Colorado Department of Public Health and the Environment, Civil Service	
Comments	Response
<p>1 Section 1 0 (page 1) and Section 3 0 (page 14) If Pu, Na, and CCl<sub>4</sub> have been selected as examples of the three types of PCOCs, then "e g" should preface each one The Site should also explain why SVOCs have been deleted as PCOCs Please note Section 6 5 2, page 90, still refers to a potential consideration of SVOC concentrations when considering thermal desorption</p>	<p>The text was revised as suggested</p>
<p>2 Section 1 0 (page 1) The bullets describing the routine actions in this RSOP could be more clearly written The following is suggested</p> <ul style="list-style-type: none"> <li>Excavation of contaminated soil according to the framework for conducting routine accelerated actions (Figures 6 and 7) and associated debris followed by offsite disposal with or without offsite treatment, and</li> <li>Excavation of contaminated soil according to the framework for conducting routine accelerated actions (Figures 6 and 7) and associated debris followed by onsite thermal desorption treatment of VOC-contaminated soil with onsite backfilling or offsite disposal</li> </ul>	<p>The text

Figure 12  
Accelerated Action Summary

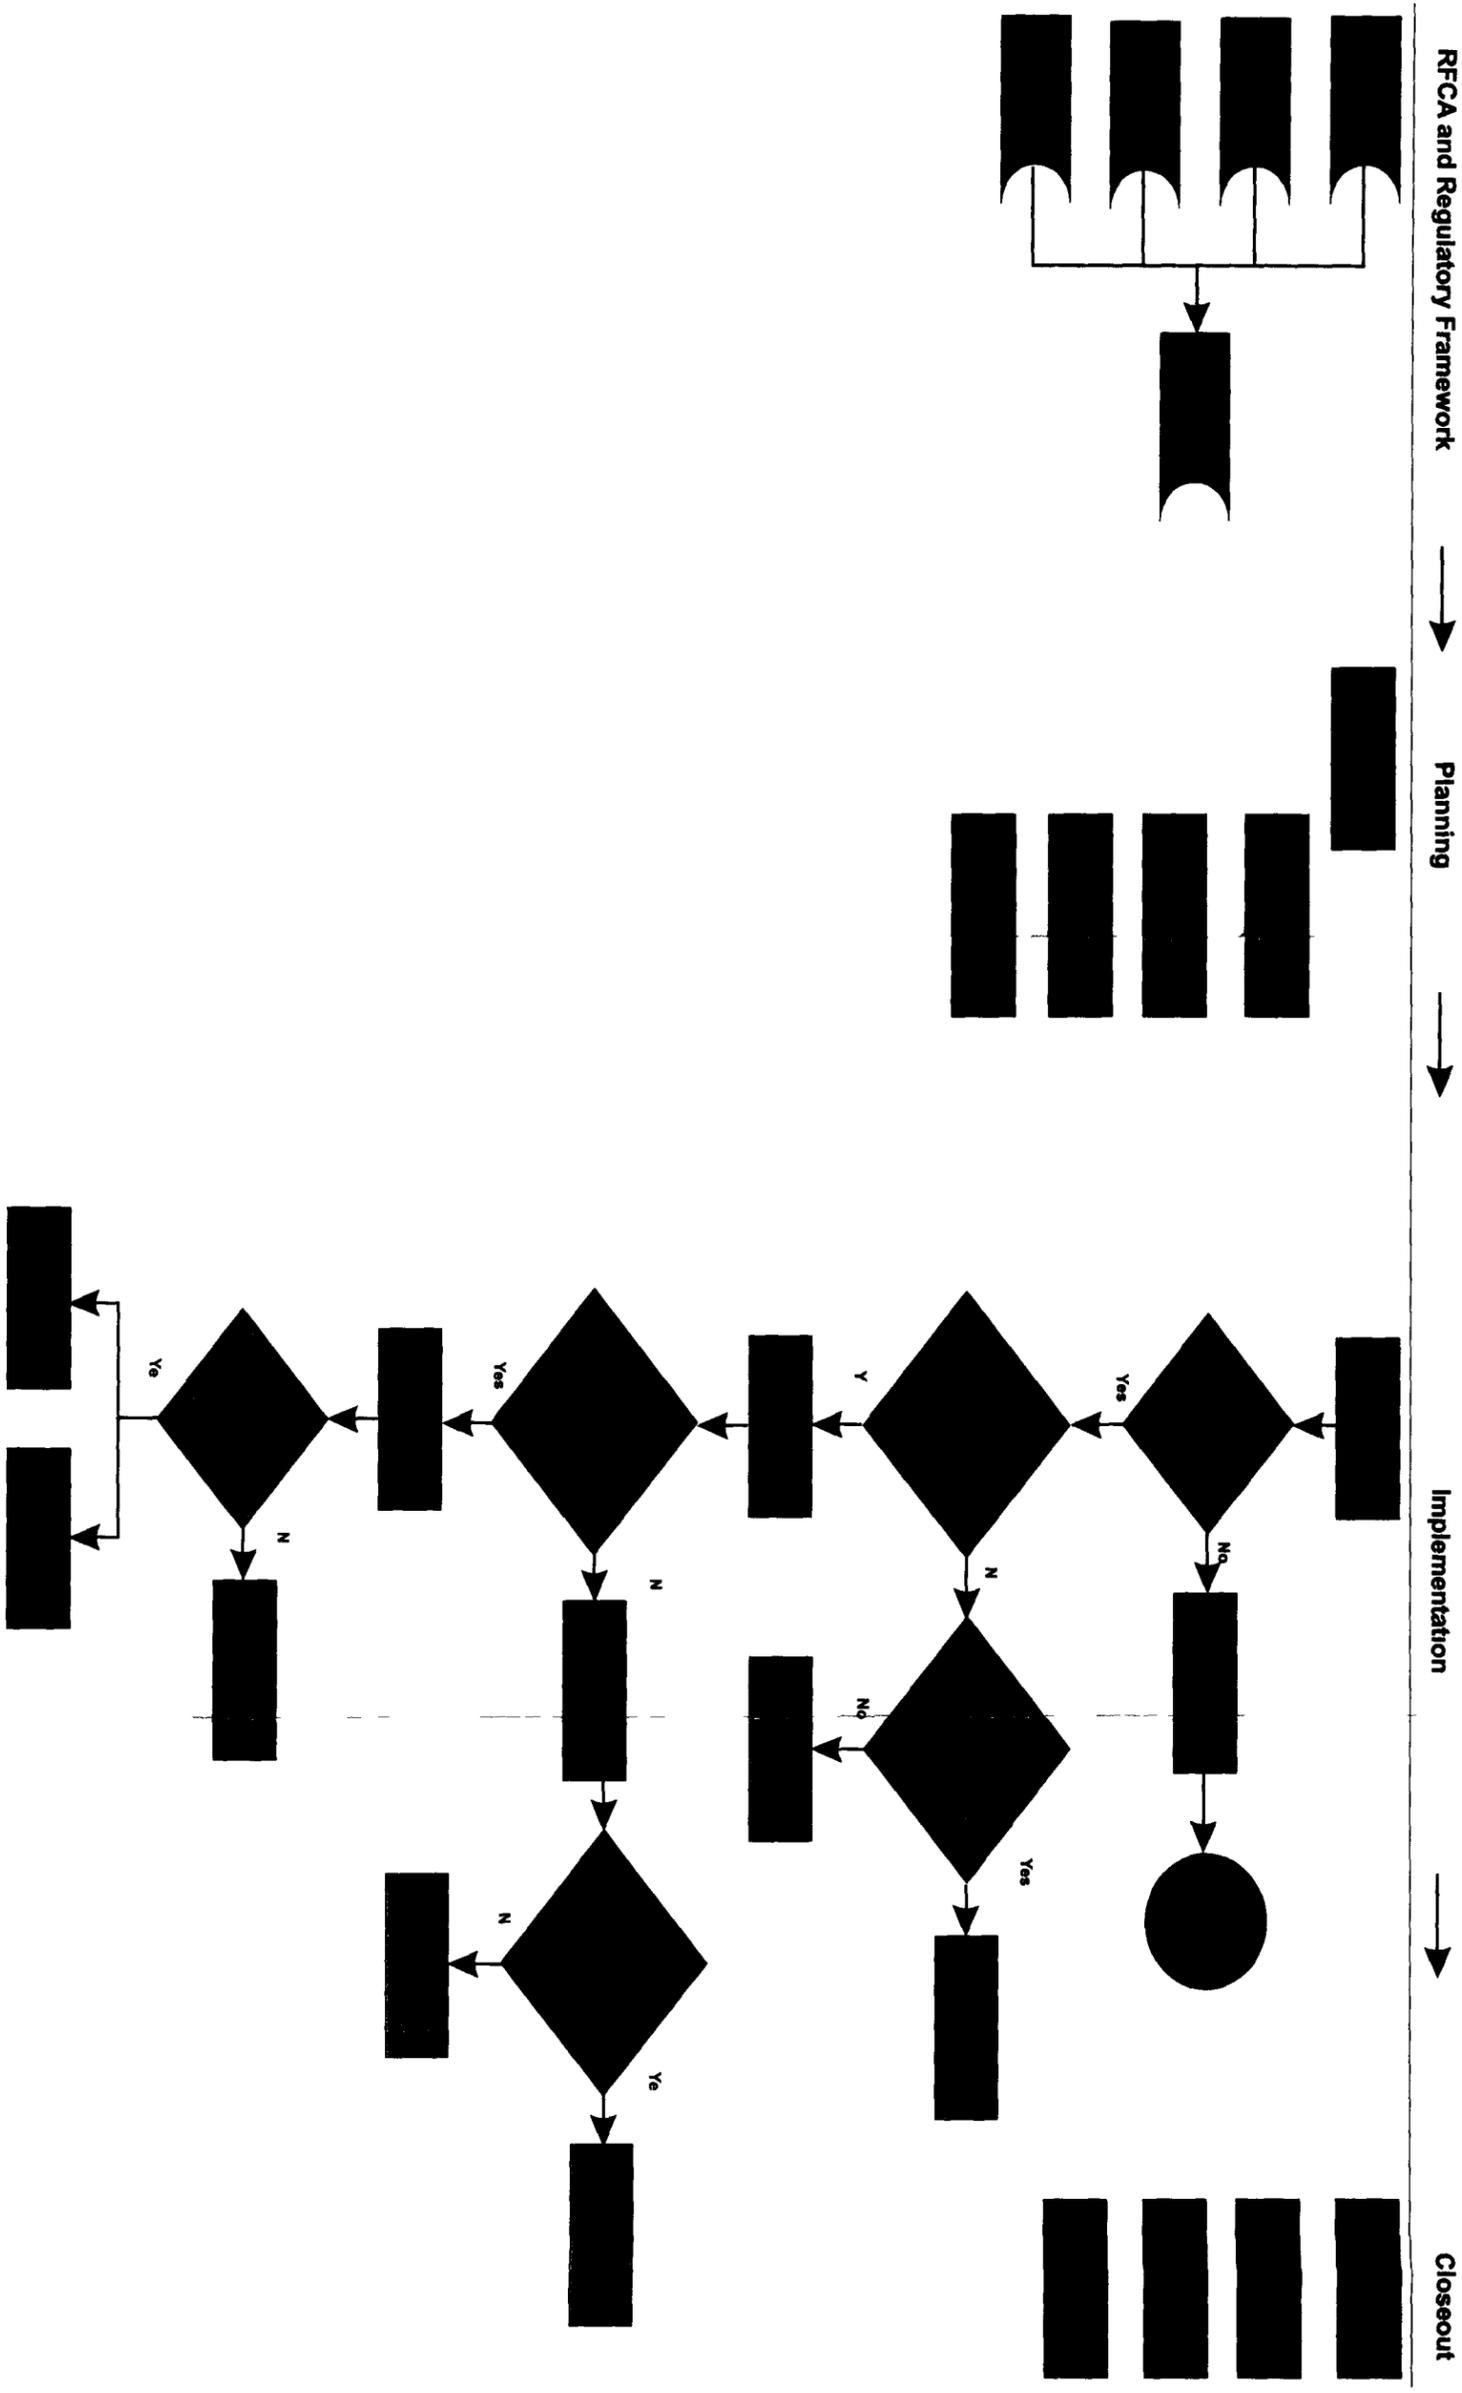
<b>Comments</b>	<b>Response</b>
<b>25</b>	<p>Figure 12, Figure 7 is referenced in the 1<sup>st</sup> diamond under <i>Implementation</i> for DQO criteria. The new Figure 7 no longer describes DQO criteria. Add a "No" to the right of the 2<sup>nd</sup> diamond under <i>Implementation</i> and replace the reference to "Tier I" with "ALs" or "WRW ALs" in the box below.</p> <p>The reference to Figure 13 in the last box, to the right, under <i>Implementation</i> is no longer valid. The "Soil Disposition" figure has been deleted. The new Figure 13 shows the ER RSOP Work Planning Process Chart.</p>	<p>The figure was revised as suggested.</p>
<b>26</b>	<p>Figure 13 Please verify that a Criticality Safety Review, in far right box, is pertinent to the ER RSOP process.</p>	<p>This is a Site requirement, although it is generally not required for ER work.</p>
<b>27</b>	<p>Section 6.5.2 (page 90) Modify the second sentence to make it consistent with Section 5.5.1 "Onsite backfilling of soil that has been treated through a thermal desorption process will be considered if the soil meets the criteria in the framework for conducting routine accelerated actions for contaminated soil (Figures 6 and 7)".</p>	<p>The text was revised as suggested.</p>
